Subject: AP1000 COL Standard Technical Report Submittal of APP-GW-GLR-101 (TR 101) Revision 1

1. APP-GW-GLR-101, Revision 1, "AP1000 Probabilistic Risk Assessment Site-Specific Considerations," Technical Report Number 101

The following DCD markup identifies how COL application Final Safety Analysis Reports should be prepared to incorporate the subject change. This section represents the original DCD Section 19.58 markup, as identified in APP-GW-GLR-101, Revision 0. No changes have been made to this text in this revision.

Figure 19.58-2.3.3-1:
Pipeline Accident Model

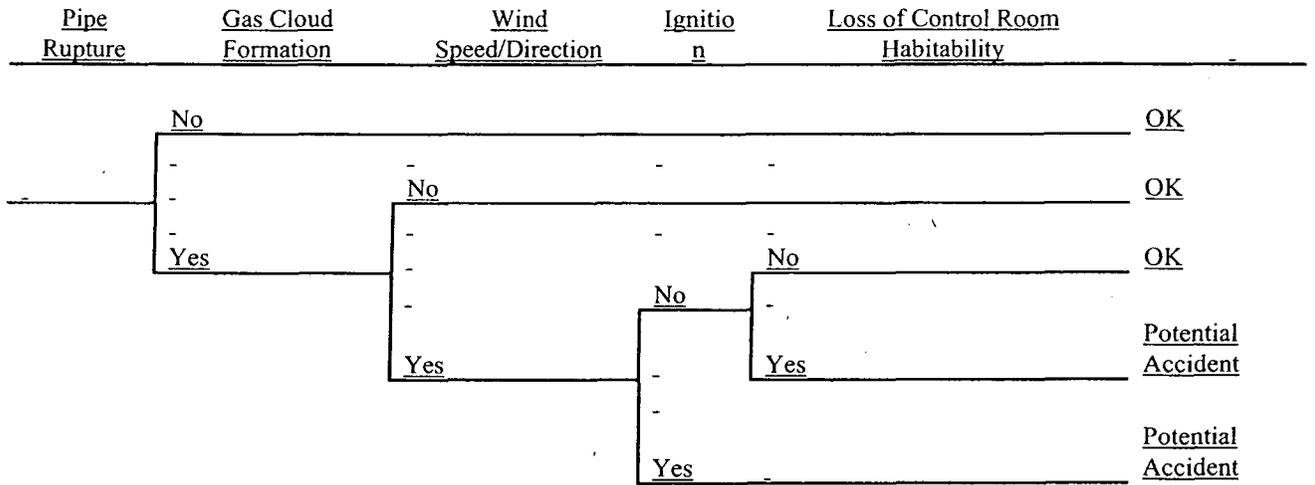
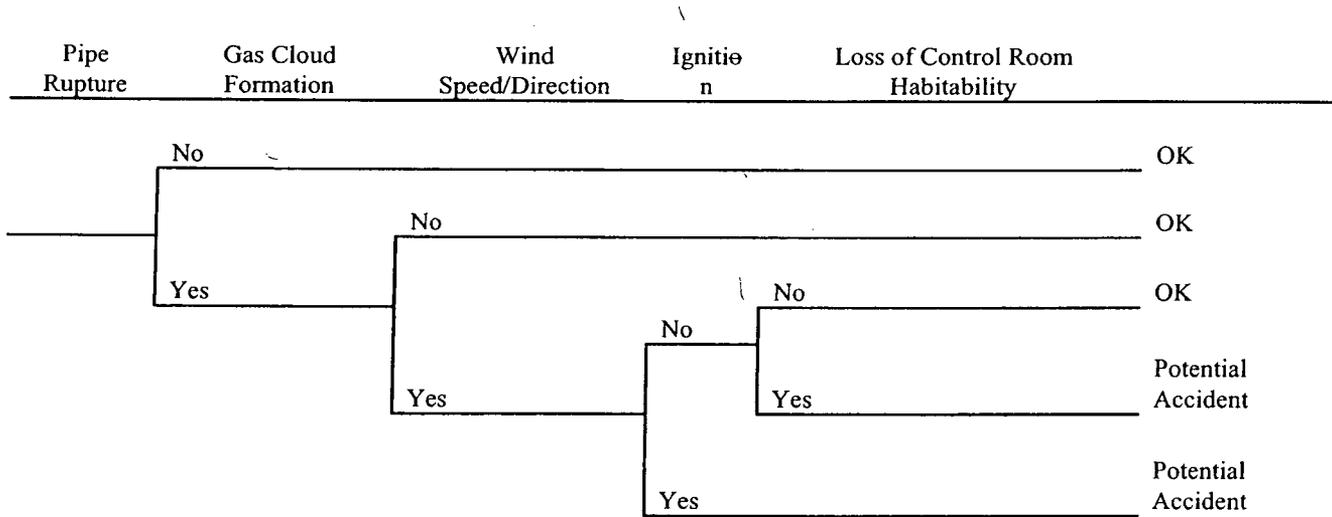
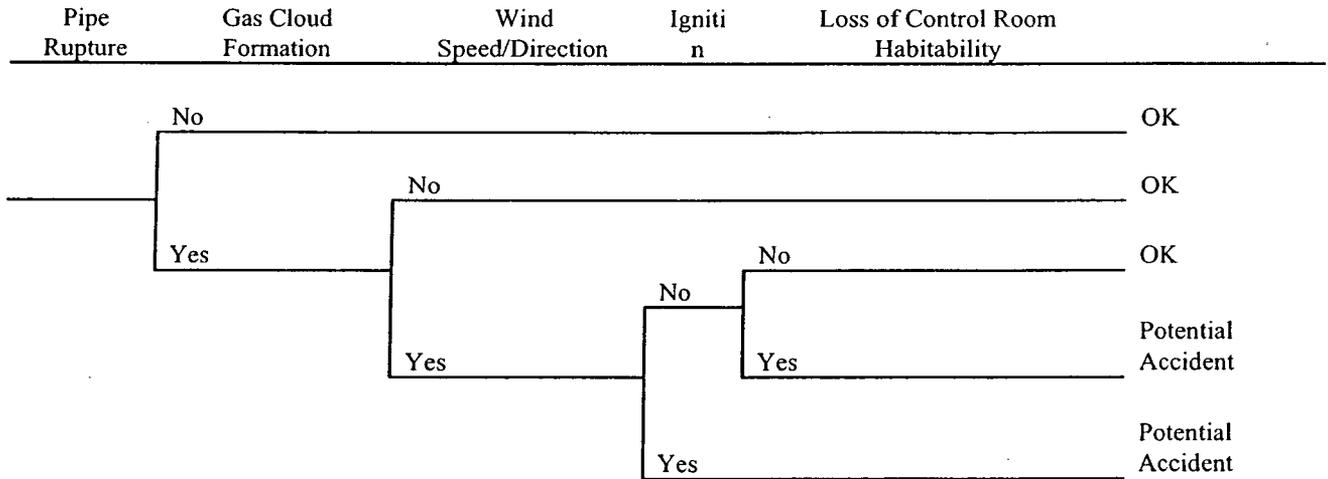
Consider Figure 19.58-2.3.3-1 to further evaluate the probability of this accident. When then considering the probability of forming a dense gas cloud, and the probability of the wind speed and direction to be in the ranges necessary to transport the gas cloud 5800 feet to the site, without dispersing the gas, including ignition of the gas cloud on-site in a location that may challenge the plant, this probability becomes very low.

Figure 19.58-1 to further evaluate the probability of this accident. When then considering the probability of forming a dense gas cloud, and the probability of the wind speed and direction to be in the ranges necessary to transport the gas cloud 5800 feet to the site, without dispersing the gas, including ignition of the gas cloud onsite in a location that may challenge the plant, this probability becomes very low.

Figure 19.59-2

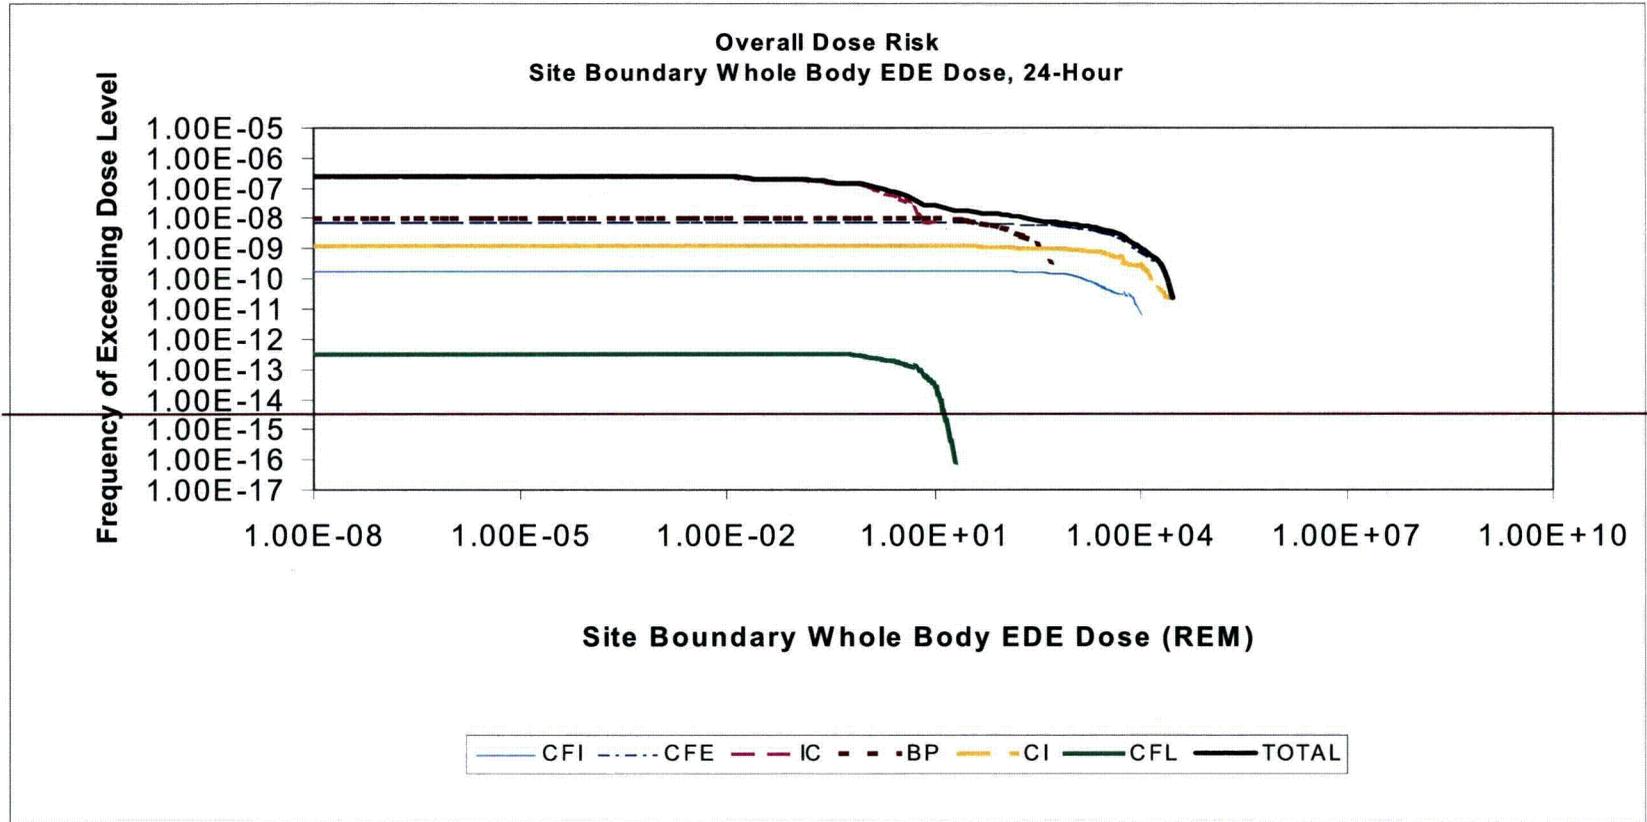
~~Figure 19.59-2 shows the 24 hour, whole body EDE site boundary dose cumulative distribution.~~

Delete Figure 19.59-2:
